# **MONITORING YEAR 5 ANNUAL REPORT**

## **AGONY ACRES MITIGATION SITE**

RE: Monitoring Year 5 Report for Agony Acres Mitigation Site (95716)  
Cape Fear River Basin (03030002)  
Guilford County, North Carolina  
Contract No. 004949

We have reviewed the comments on the Monitoring Year 5 Report for the above referenced project dated November 7, 2019 and have revised the report based on these comments. The revised documents are submitted with this letter. Below are responses to each of your comments. For your convenience, the comments are reprinted with our response in italics.

Figures 3.0 - 3.3 Integrated Current Condition Plan View

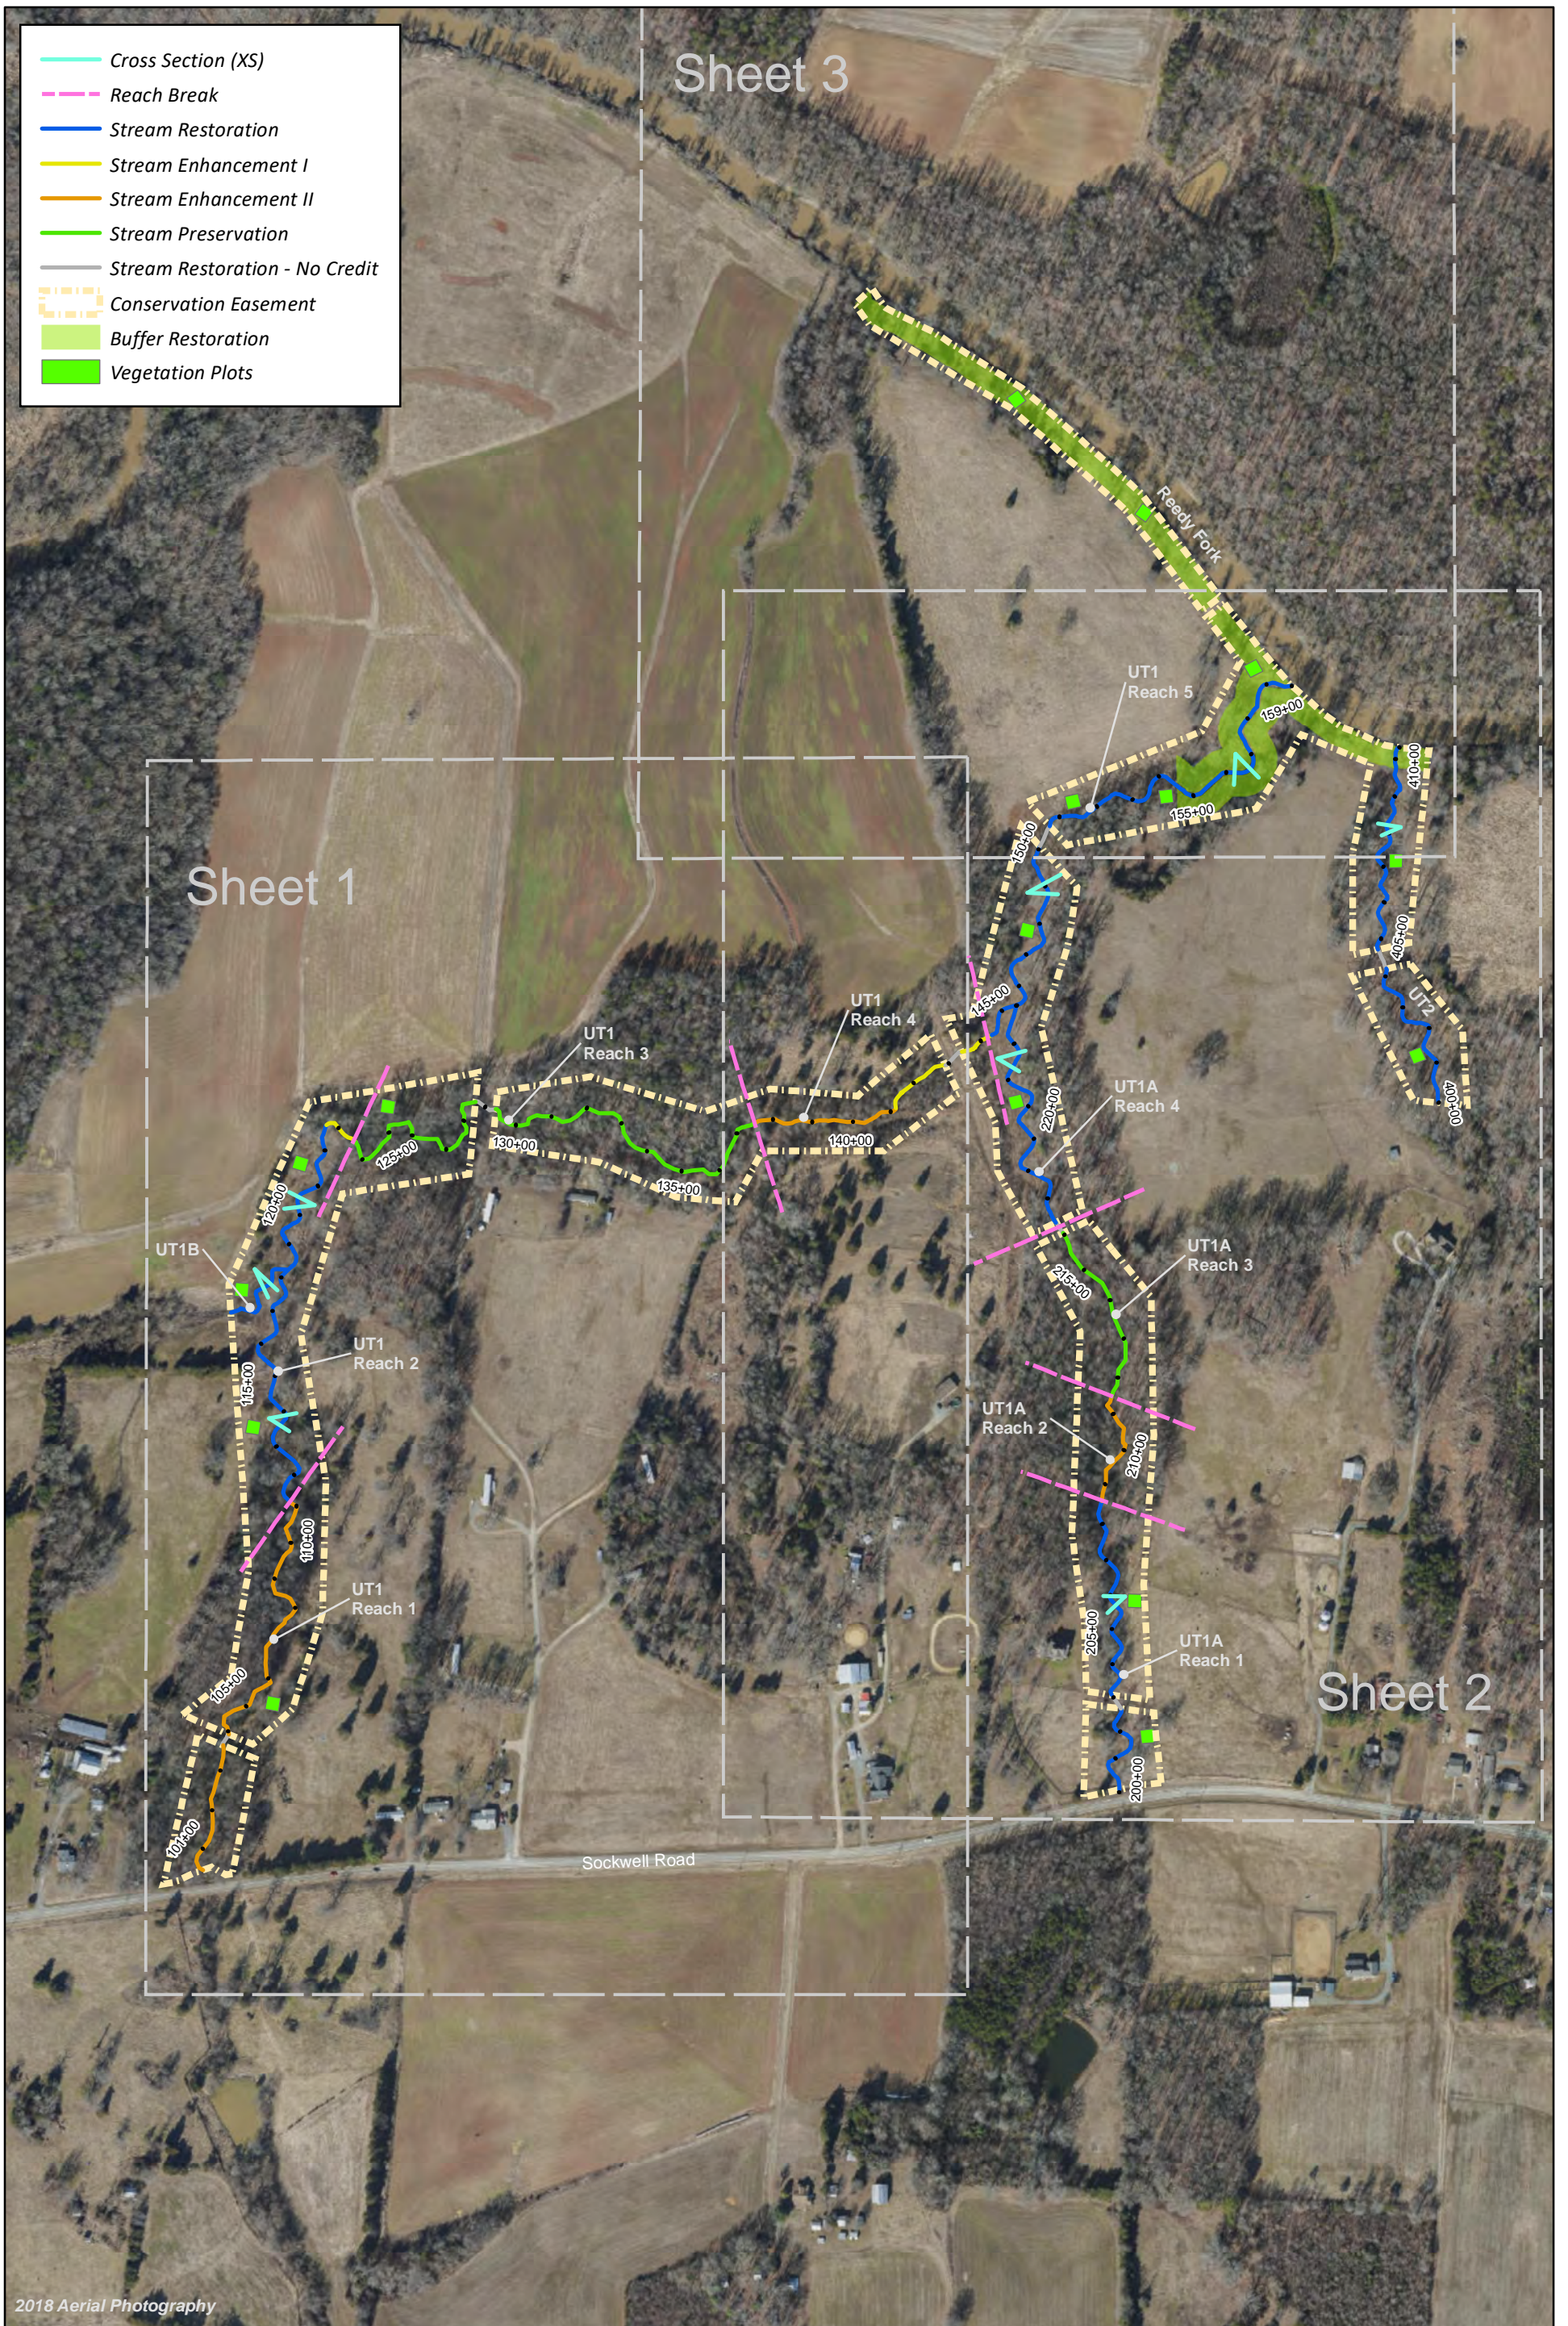
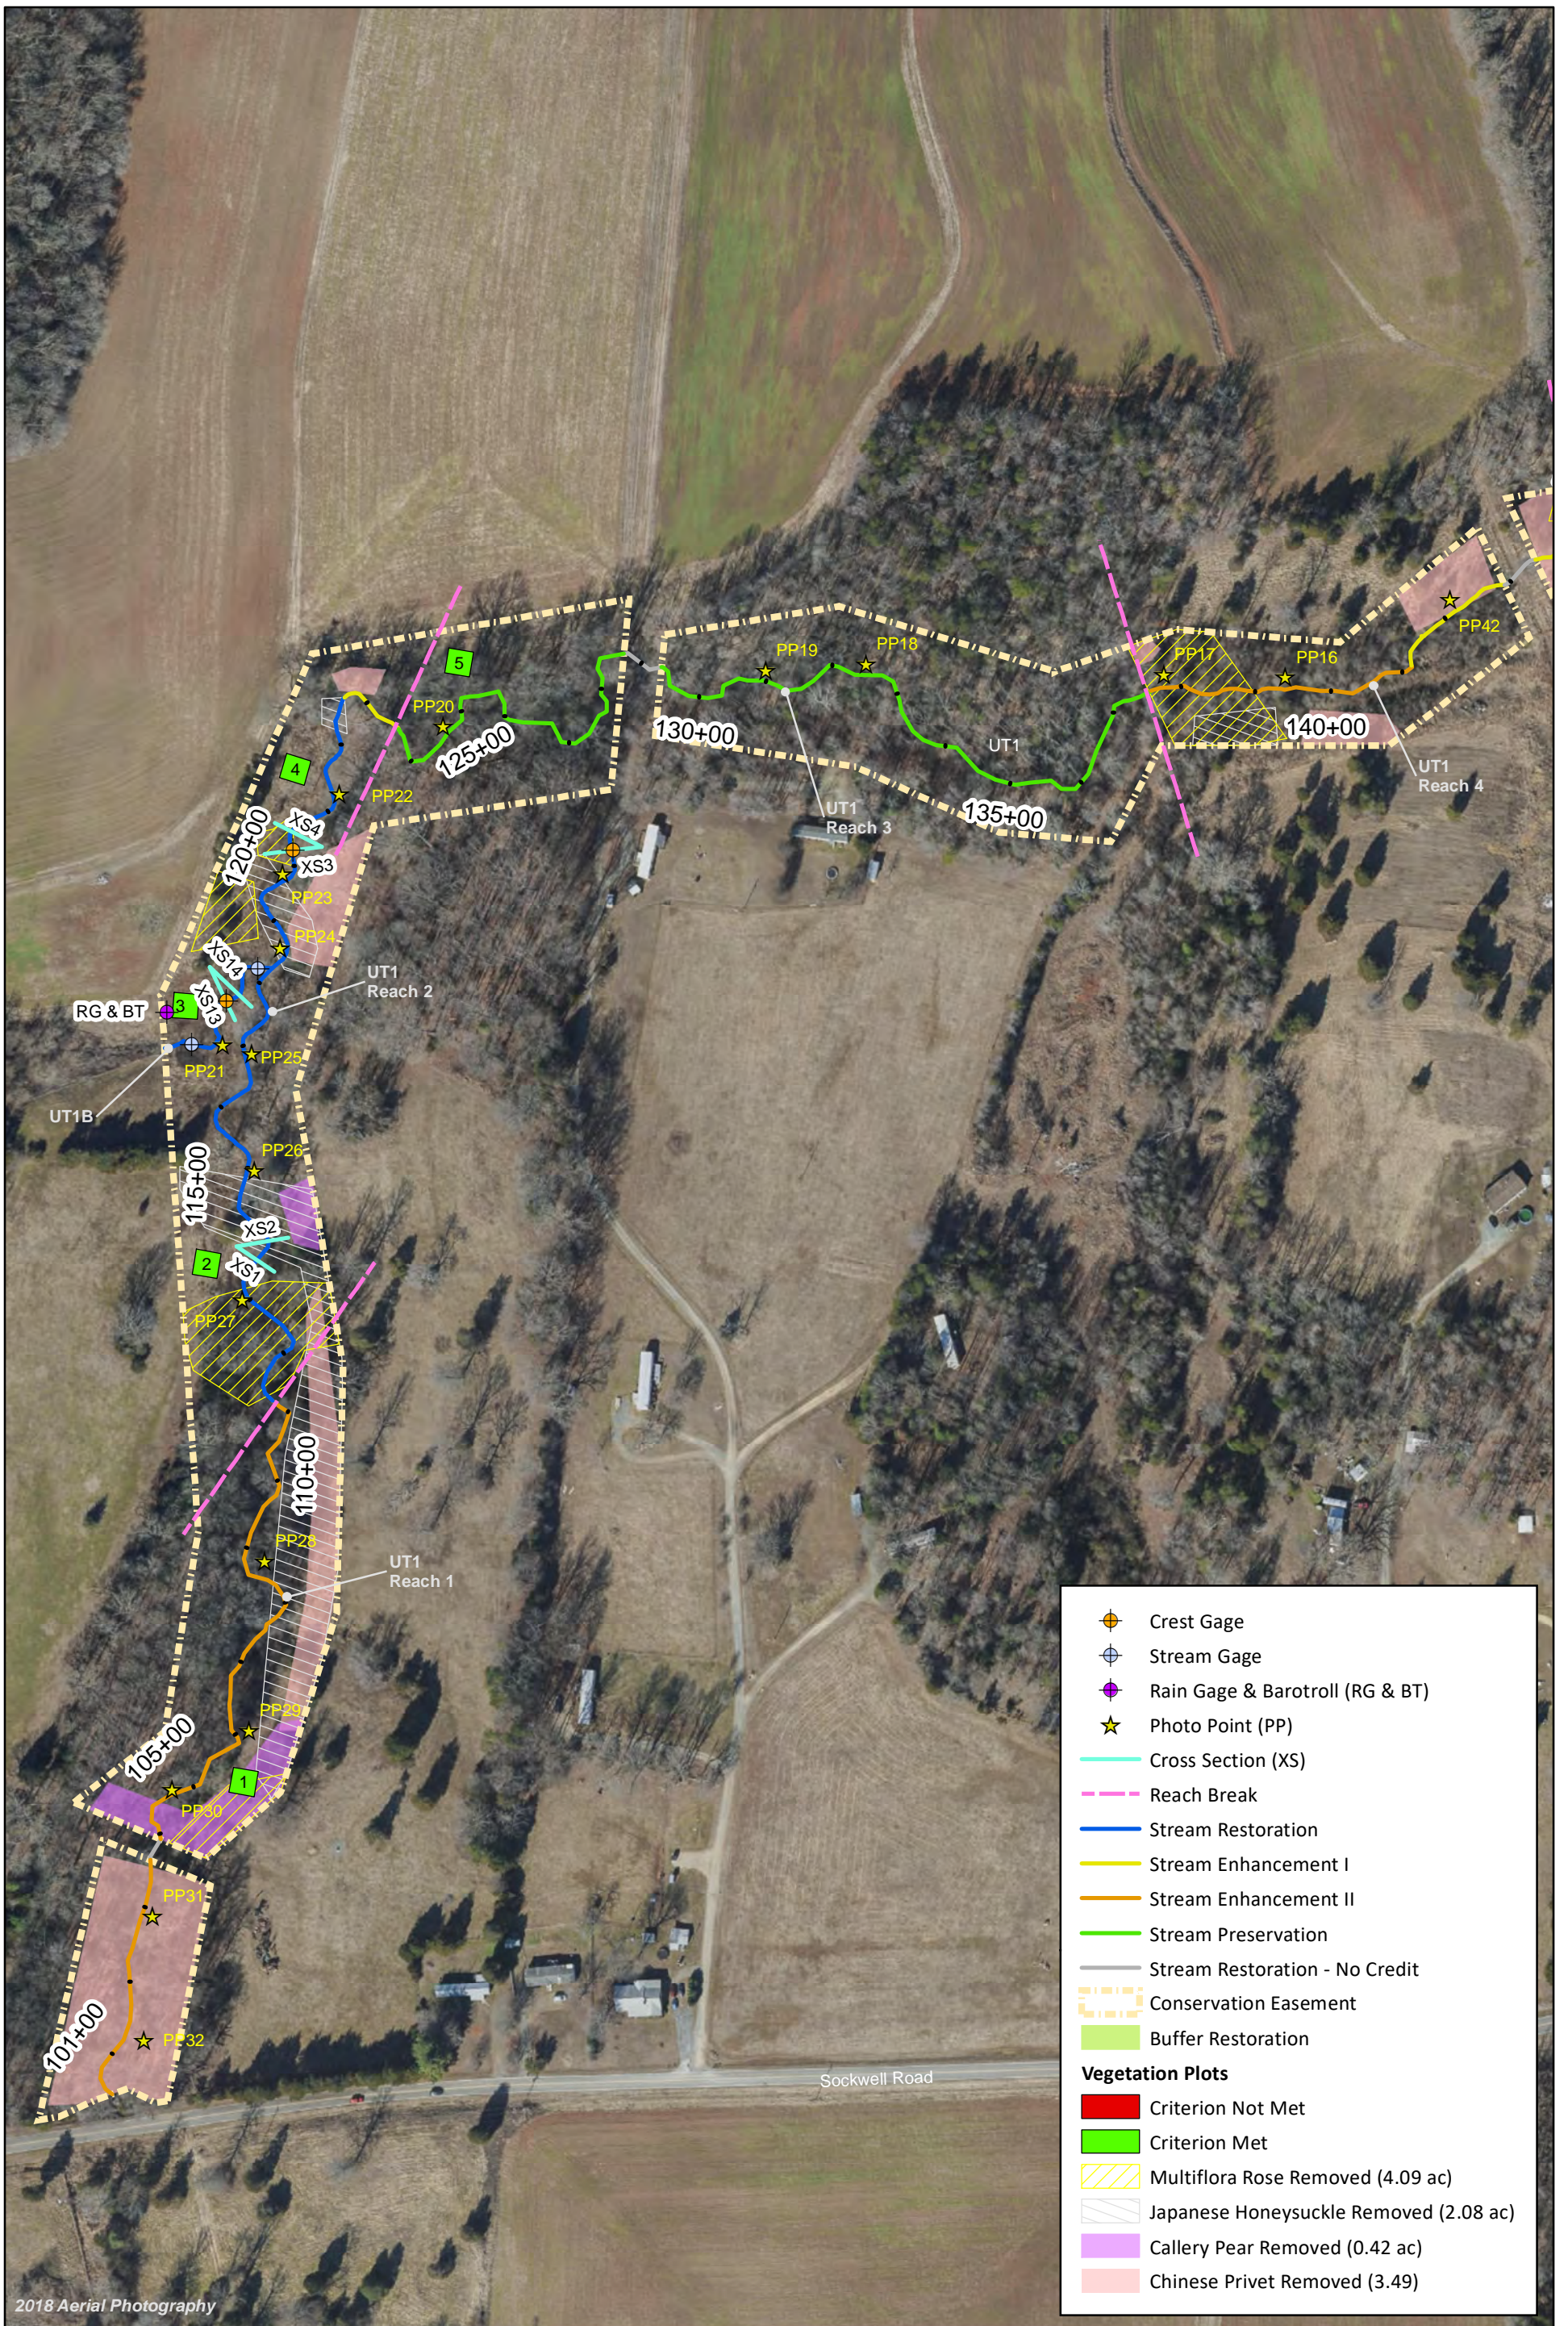
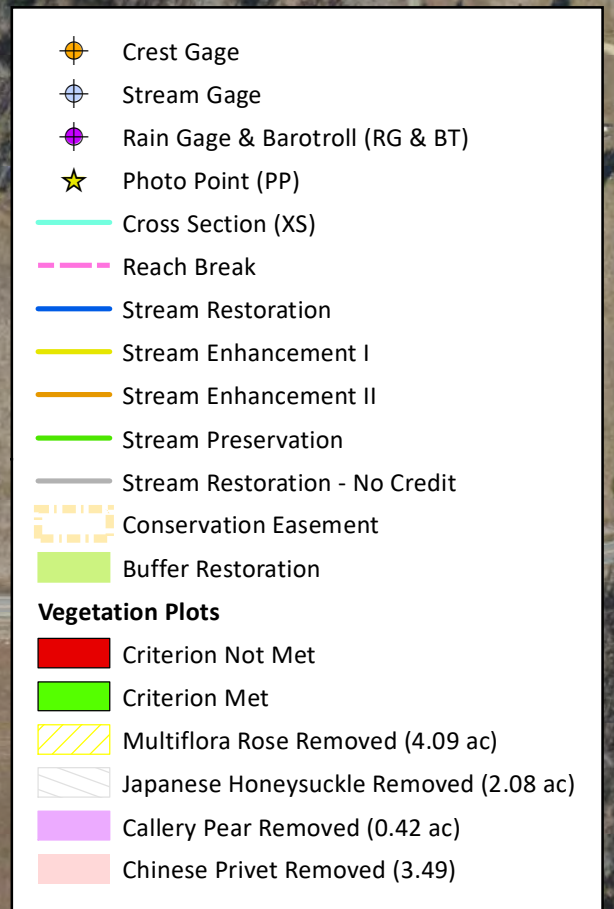
The last sentence has been reworded to avoid misinterpretation.
3. Section 1.2.5  
Per IRT comments during the site visit on Nov. 6, please include a brief discussion of UT1A flow gauge data here.  
*A discussion of the UT1A flow gauge data has been added.*
4. Appendix 2  
Figure 3.2 – Please add UT1A flow gauges to CCPV.  
*UT1A flow gauges have been added to the CCPV.*
